ORDER OF CONDITIONAL
APPROVAL OF FINAL PLAT

ORDER OF CONDITIONAL APPROVAL OF FINAL PLAT
FOR KINGSTOWN SUBDIVISION NO. 1 FP-2023-0007

SUBJECT: Kingstown Subdivision No. 1 - FP
[FP-2023-0007](#)

Final plat consisting of 17 buildable lots and 4 common lots on 4.17 acres of land in the R-8 zoning district for Kingstown Subdivision No. 1.

B. Final Plat (date: 7/20/2023)

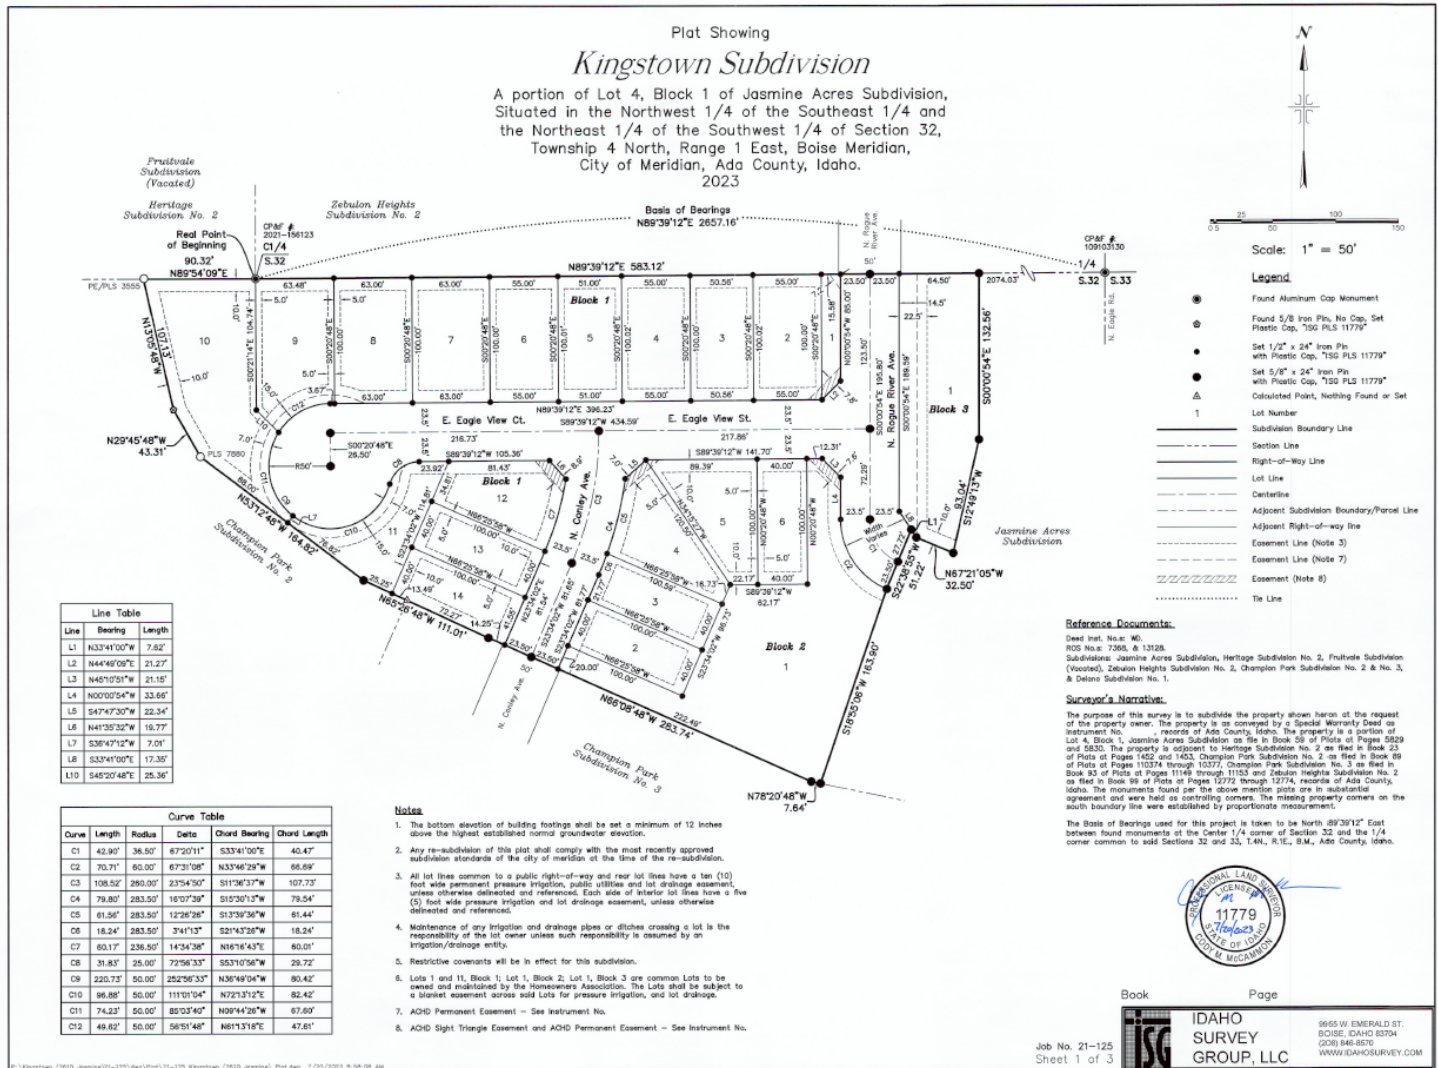
3. Prior to submittal for the City Engineer's signature, have the Certificate of Owners and the accompanying acknowledgement signed and notarized.
4. The final plat shown in Section V.B, prepared by Idaho Survey Group, stamped on 07/20/23 by Cody M. McCammon, shall be revised prior to signature on the final plat by the City Engineer, as follows:

- a. Include the phase number (i.e. #1) in the subdivision name.
 - b. Note #7: Include recorded instrument number of ACHD permanent easement.
 - c. Note #8: Include recorded instrument number of ACHD sign triangle easement and ACHD permanent easement.
